DATE: August 21, 2013

SUBJECT: Addendum No. 1
U.S. 50/Silva Valley Interchange
PW 12-30647, CIP No. 71328

ITEM NO.	LOCATION, PAGE, OR DRAWING NO.	DESCRIPTION OF CHANGE
1. 1.	N-3	Refer Response to Bidders' Inquiries No. 3 Item 3.30. Add to the end of OBTAINING OR INSPECTING CONTRACT DOCUMENTS in the Notice to Bidders: "Email with the completed Electronic File Usage Acknowledgment Form requests for electronic files of the existing and proposed contours in AutoCAD (.dwg) format to Janel.Gifford@edcgov.us . Once the signed Electronic File Usage Acknowledgment Form is received the County will email the files to the email address shown on the Electronic File Usage Acknowledgment Form." The Electronic File Usage Acknowledgment Form is attached to this Addendum as Attachment A .

Dist	COUNTY	ROUTE	POST MILES TOTAL PROJECT	SHEET No.	TOTAL SHEETS
03	ED	50	1.02/R2.40	179	371

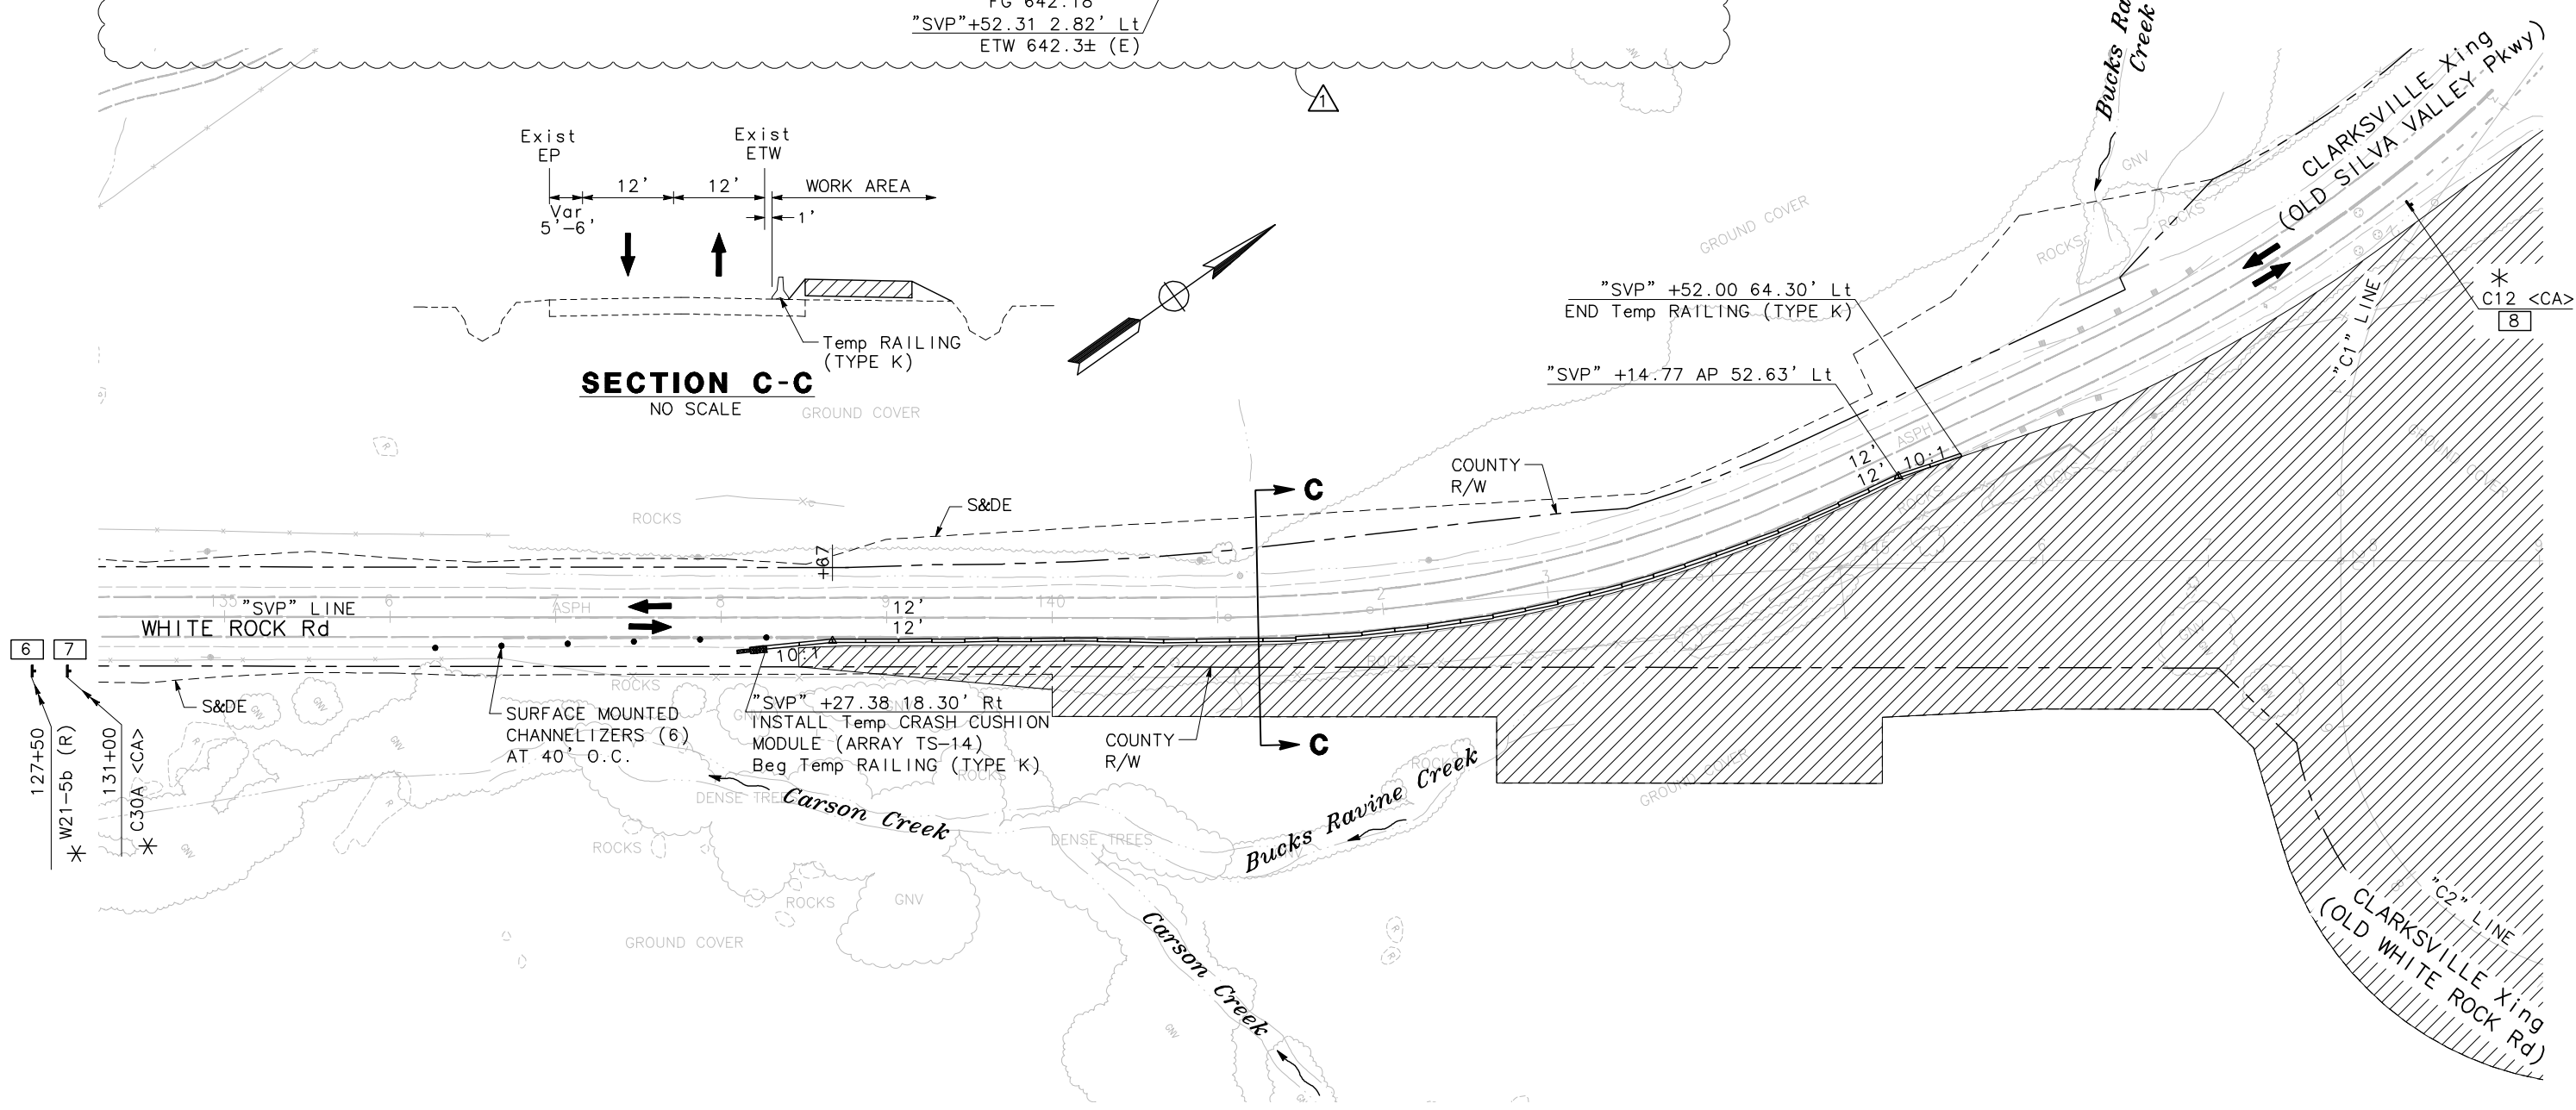
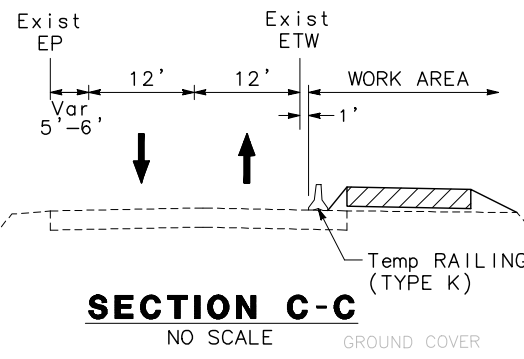
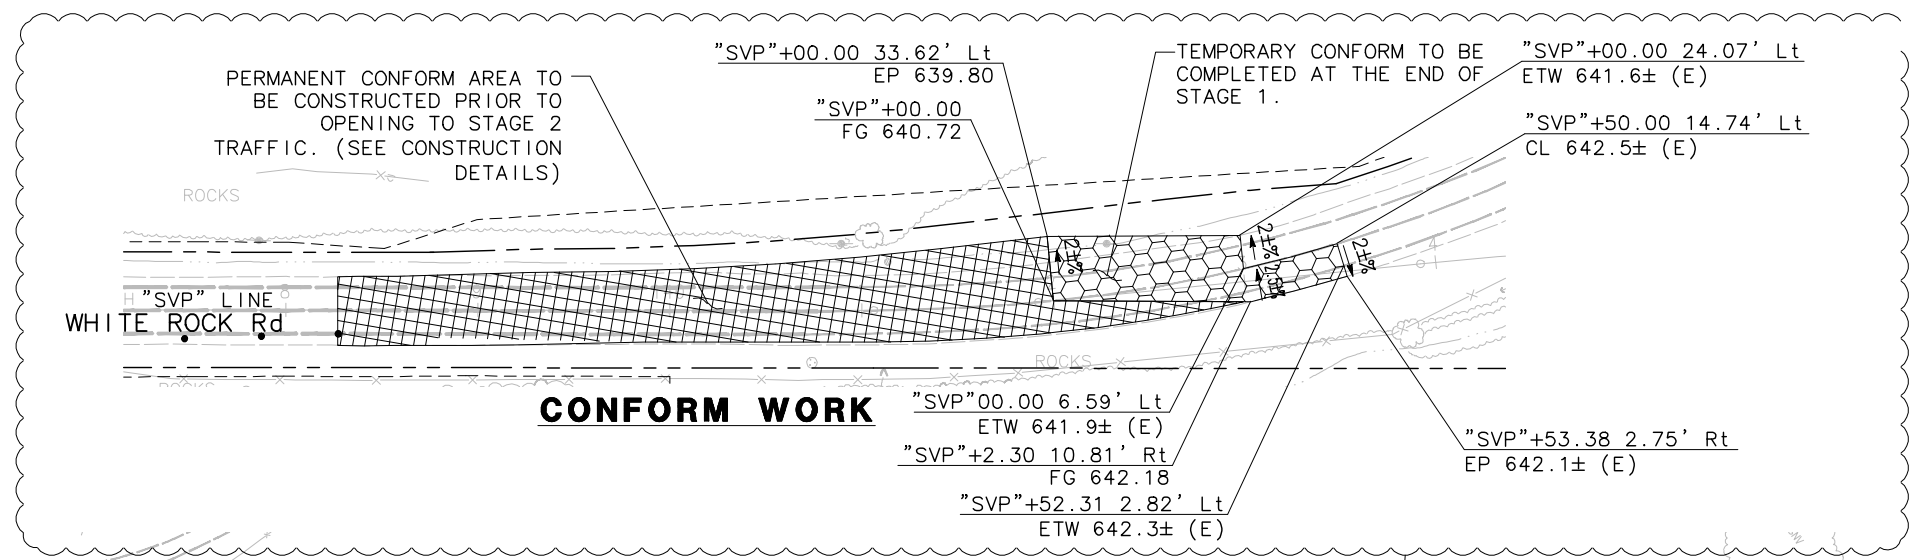
1. 22.	Plan sheets 179 and 180	Bidders are instructed to replace Plan sheets 179 and 180 with revised Plan sheets 179 and 180 attached to this Addendum.

DIST	COUNTY	ROUTE	POST MILES TOTAL PROJECT	SHEET No	TOTAL SHEETS
03	ED	50	1.07/R2.40	340	371

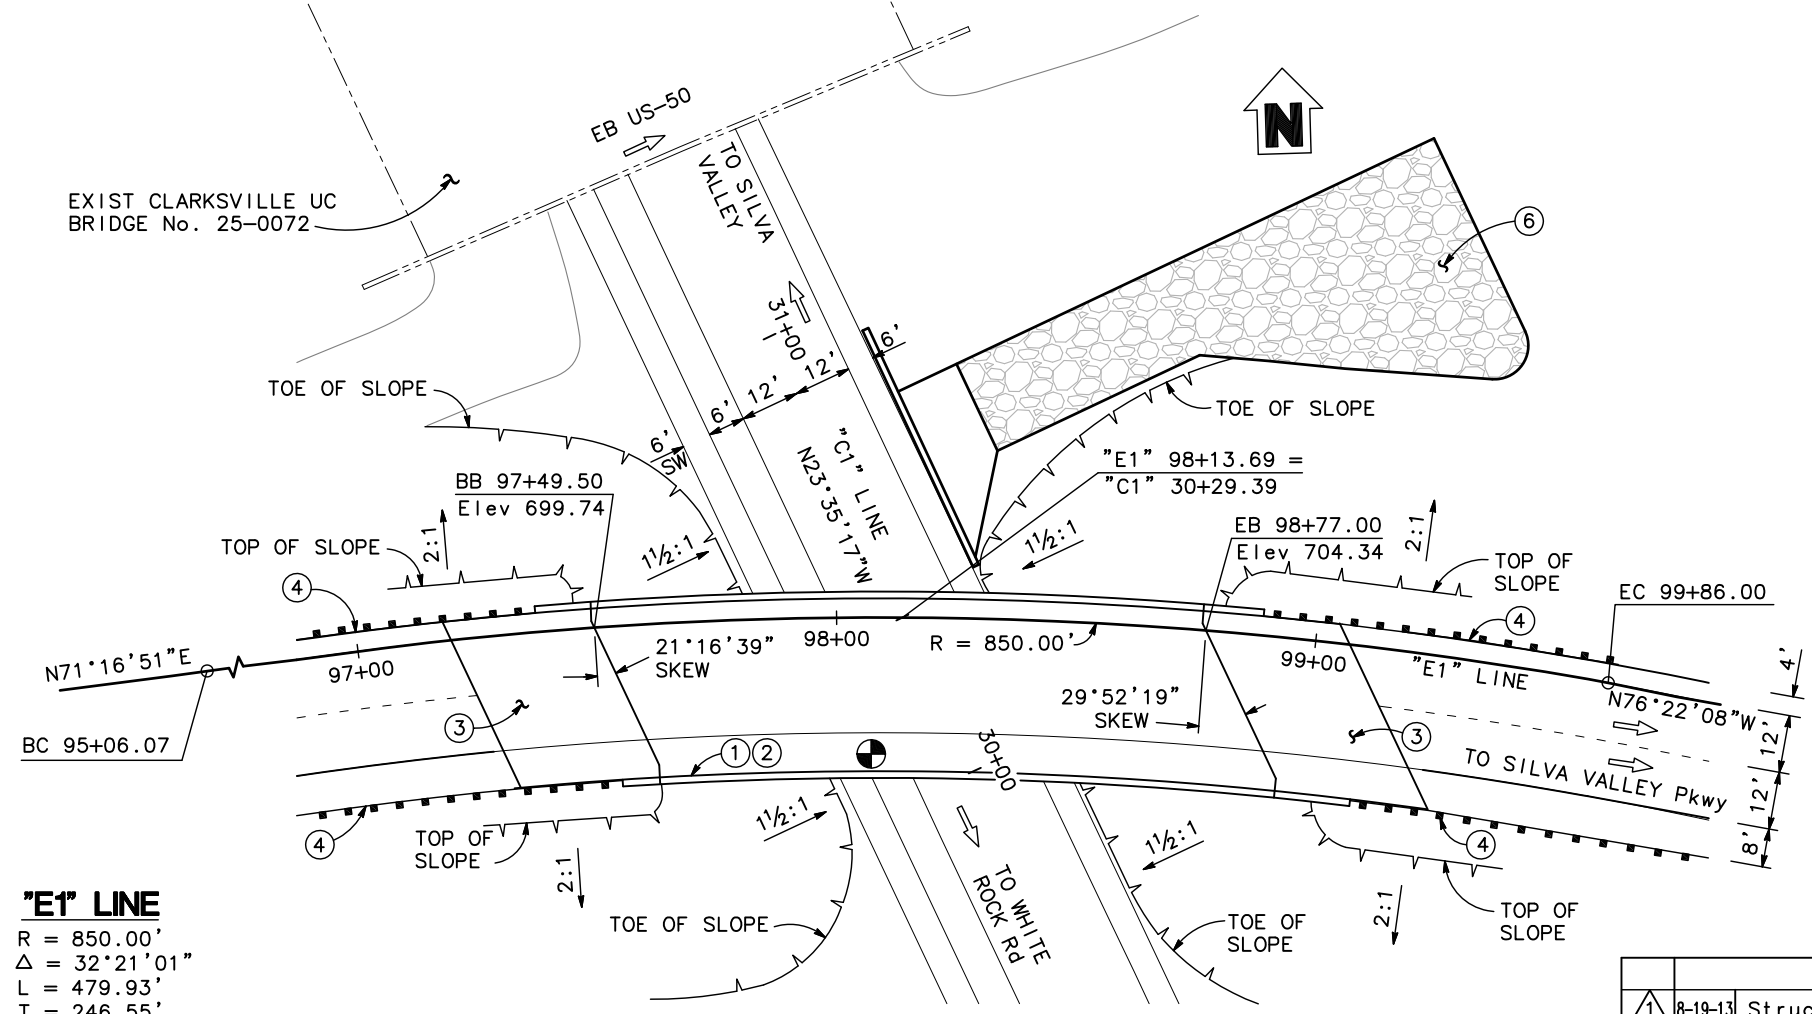
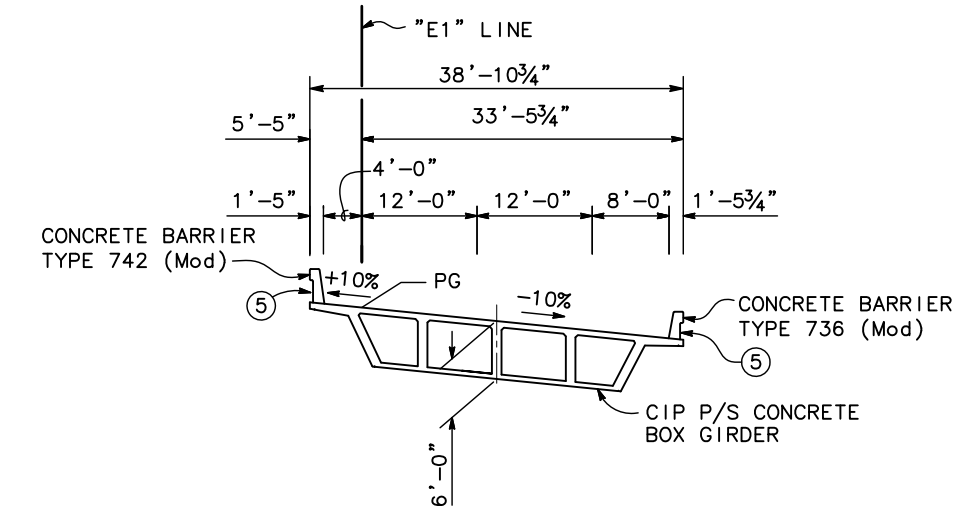
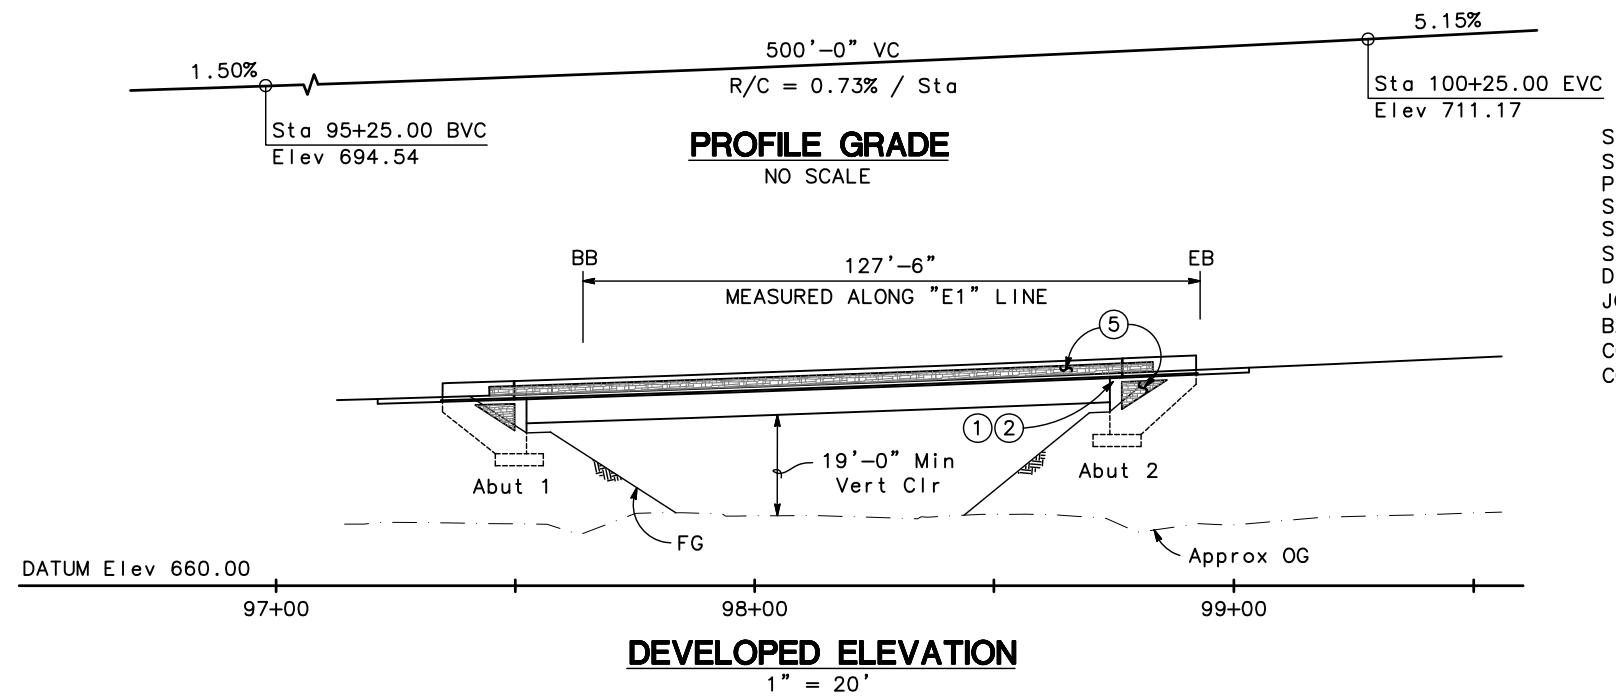
1. 26.	Plan sheet 340	Bidders are instructed to replace Plan sheet 340 with revised Plan sheet 340 attached to this Addendum.
1. 27.	SP-69	Add to the first sentence of Section 13-11.01C after "...in this Certification": "and to the California Department of Fish and Game before commencement of diversion." Add to the last sentence of Section 13-11.01C ", the Streambed Alteration Agreement, and the U.S. Fish and Wildlife Service requirements." Replace section 13-11.02 with "Any temporary dam or other artificial obstruction constructed must only be built from clean materials such as sandbags, gravel bags, water dams, port-a- dams, water bladder dams, K-rails, driven sheet metal coffer dams, or clean/washed gravel which will cause little or no siltation."
